**HUGHES
SERVICE INFORMATION
NOTICE**

NOTICE NO. N-91

SUBJECT: MAIN ROTOR TRANSMISSION MODIFICATION KIT (P/N M10062)

MODELS AFFECTED: 269A (TH-55A) Helicopter Serial Nos. 0315 and subsequent

FIGURE 1. KIT INSTALLATION M10062-5 - INPUT PINION BEARING REPLACEMENT.

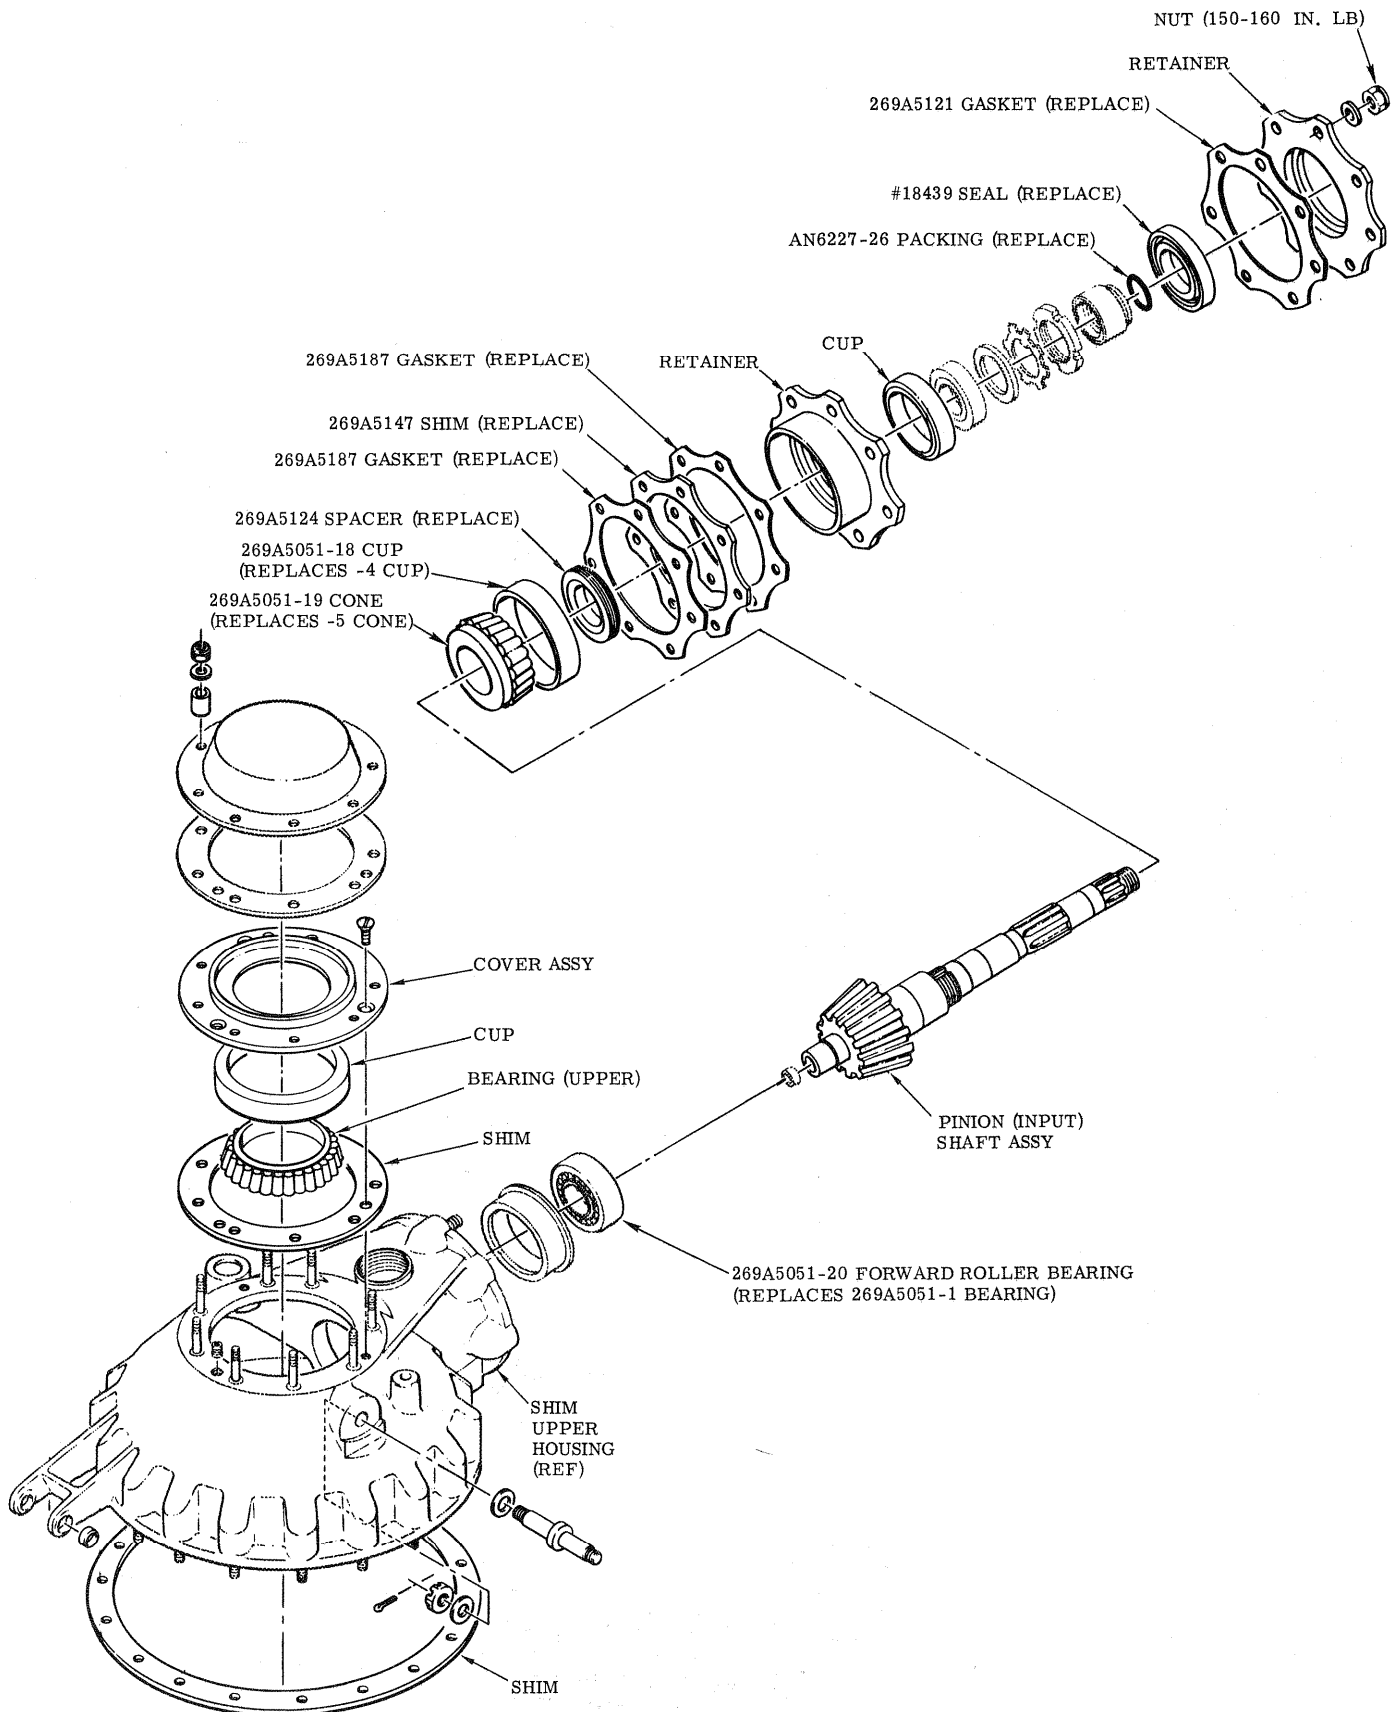
- c. Remove, disassemble, clean and inspect main transmission (Section 10, Basic HMI).
- d. Disassemble main gearbox pinion assembly (Section I, HMI Appendix C).
- e. Disassemble main gearbox upper housing (Section I, HMI Appendix C).
- f. Measure and reassemble main gearbox pinion assembly (Section I, HMI Appendix C); install new components as follows (See Figure 1):

269A5051-19 Cone	(Replaces 269A5051-5)
269A5051-18 Cup	(Replaces 269A5051-4)
269A5124 Spacer	(Replaces same)
269A5147 Shim	(Replaces same)
269A5187 Gasket	(Replaces same - 2 required)
AN6227-26 Packing	(Replaces same)
18439 Seal	(Replaces same)
269A5121 Gasket	(Replaces same)

g. Reassemble main gear drive upper housing (Section I, HMI Appendix C); install new 260A5051-20 forward roller bearing as replacement for existing 269A5051-1 bearing (See Figure 1).

FIGURE 2. MAIN ROTOR TRANSMISSION-SEALING MODIFICATION (SHEET 1 of 2)

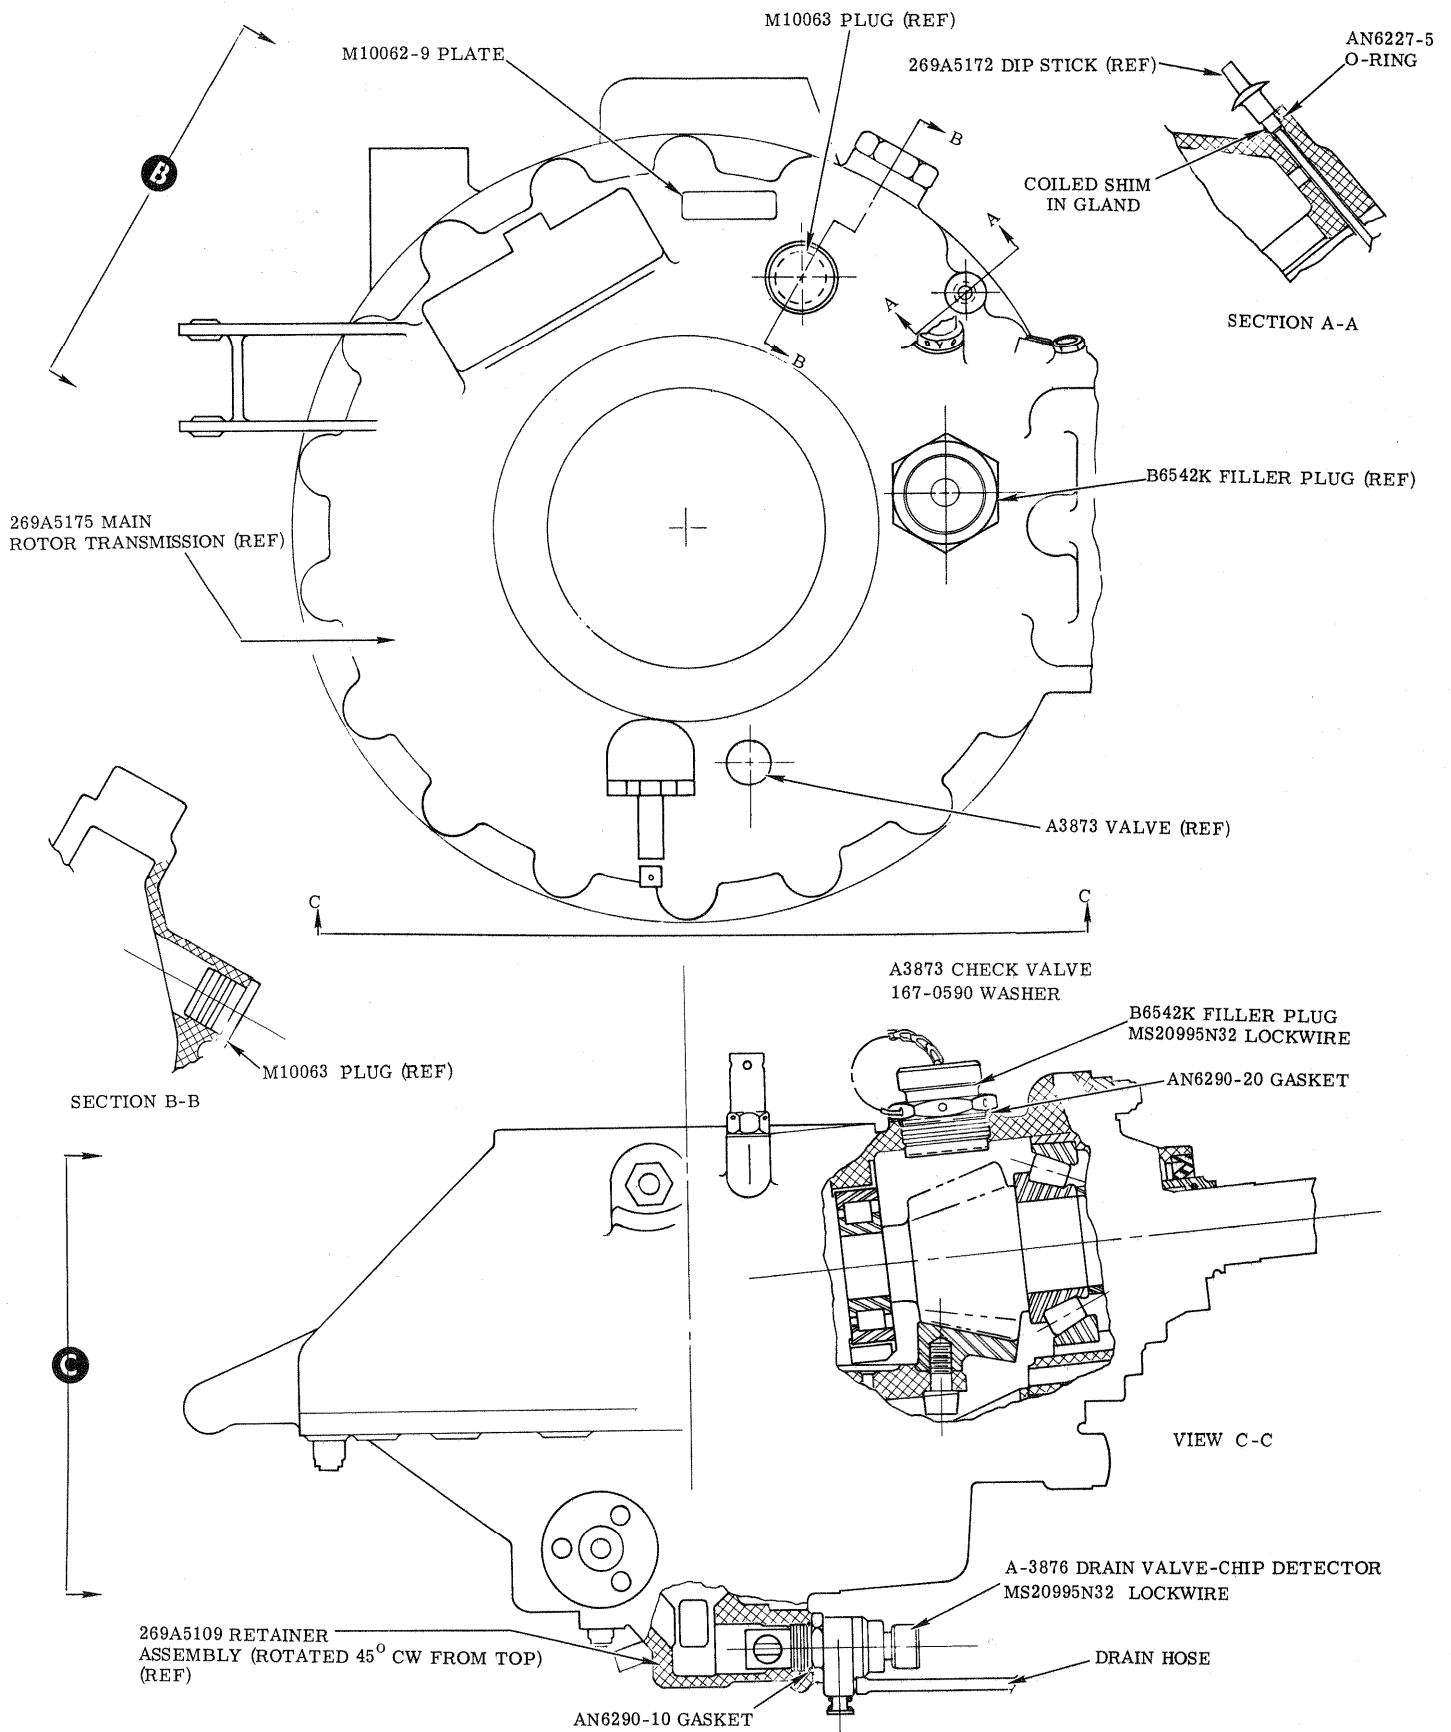
1. Install new AN6277-5 dip stick "O"-ring as follows (See Figure 2 Sheet 1).
 1. Clean gland thoroughly.
 2. Using "Grip" cement, bond a coiled shim (made of 0.0015 inch thick stainless steel shim stock 1.70 inch long by 0.10 inch wide) in gland.
 3. Install new AN6227-5 "O"-ring immediately.
 4. Insert dip stick and allow cement to dry (approx. 45 minutes).

a. Remove following components from transmission housing and install new or replacement parts as noted below (See Figure 2):

314639 Bolt & Air Vent Assy	(Replace with A3873 Check Valve)
AN814-20DL Inspection Plug	(Replace with B6542K Filler Plug)
AN6290-20 Gasket	(Replace with same)
A722 Magnetic Drain Valve	(Replace with A3876 Drain Valve)
AN6290-10 Gasket	(Replace with same)
269A5151 Filler Cap and 269A5156 Strainer Assy	(Replace with M10063 Plug)

b. Install new AN6227-5 dip stick "O"-ring as follows (See Figure 2 Sheet 1):

1. Clean gland thoroughly.
2. Using "Grip" cement, bond a coiled shim (made of 0.0015 inch thick stainless steel shim stock 1.70 inch long by 0.10 inch wide) in gland.
3. Install new AN6227-5 "O"-ring immediately.
4. Insert dip stick and allow cement to dry (approx. 45 minutes).

FIGURE 2. MAIN ROTOR TRANSMISSION - SEALING MODIFICATION (SHEET 2 of 2)

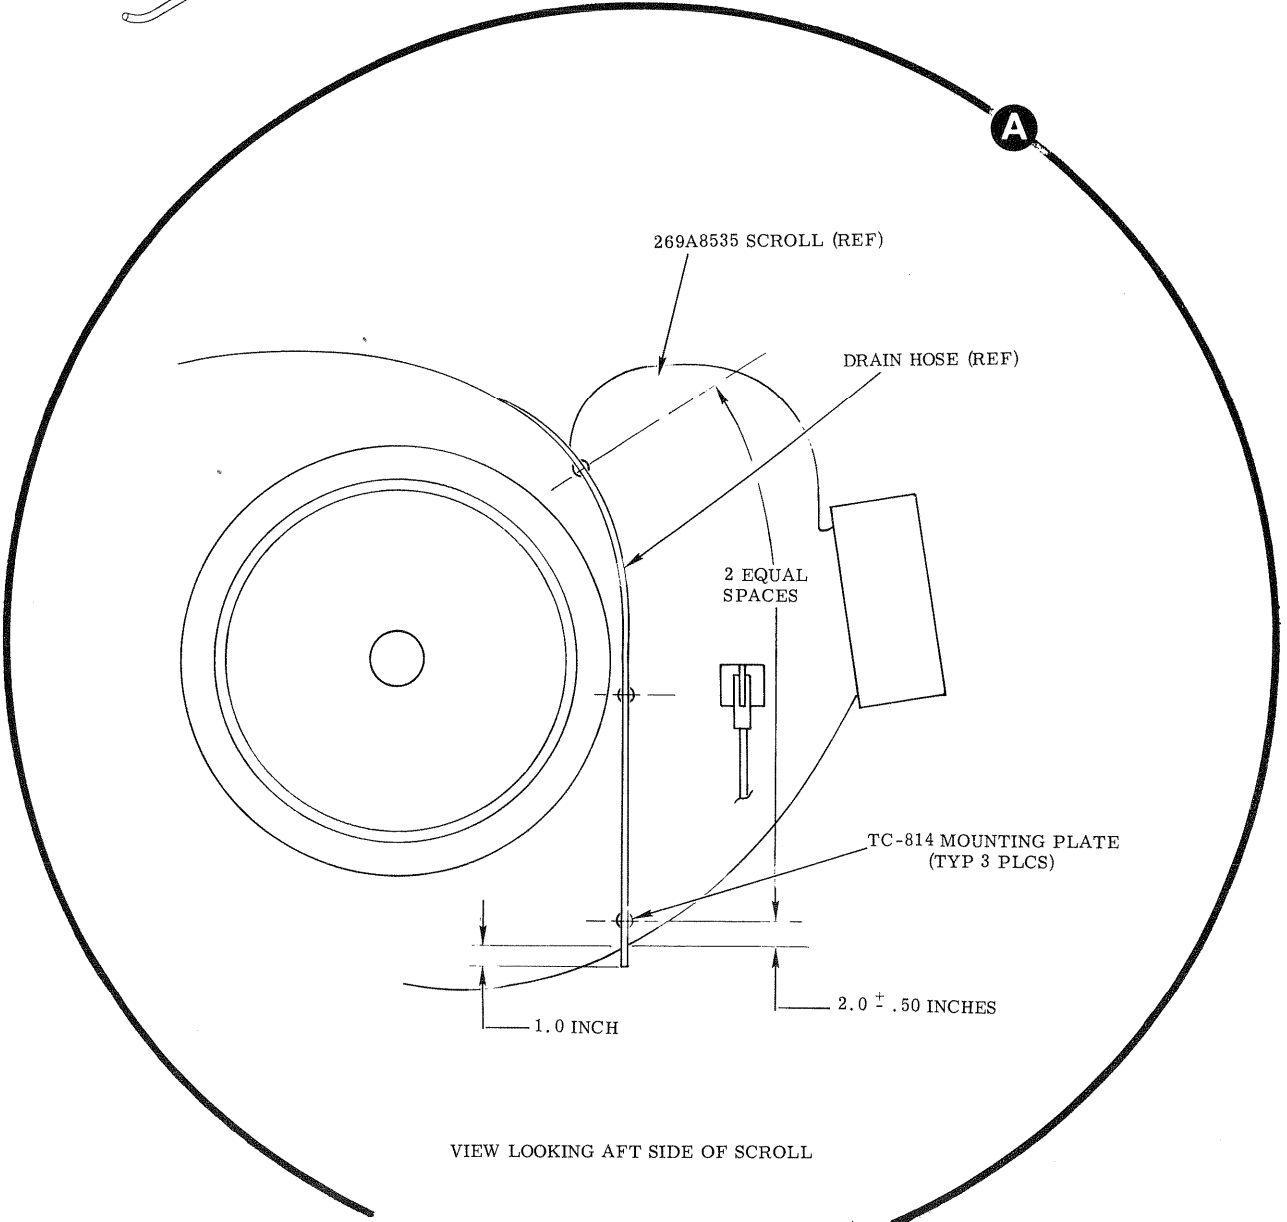
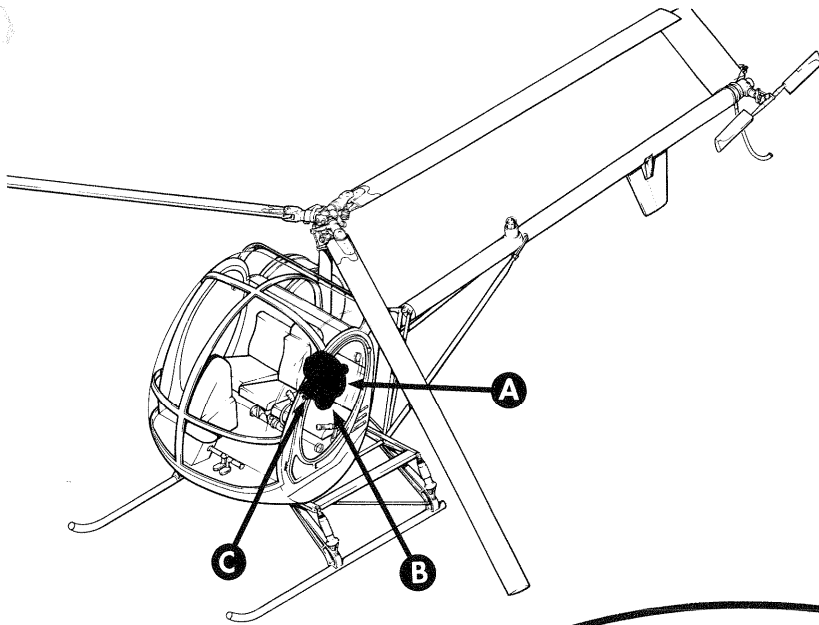
1. Rivet Ty-Mounts three places to aft face of scroll assembly at dimensions shown in Figure 2 Sheet 2; installation of washer under heads is optional.
2. Reinstall scroll assembly (Section 6, Basic HMI).
3. Route drain hose down aft face of scroll and secure at Ty-Mounts with Sta-Straps.

1. Rivet Ty-Mounts three places to aft face of scroll assembly at dimensions shown (See Figure 2 Sheet 2); installation of washer under head is optional.
2. Route drain hose down forward face of scroll and secure at three Ty-Mounts with Sta-Straps.
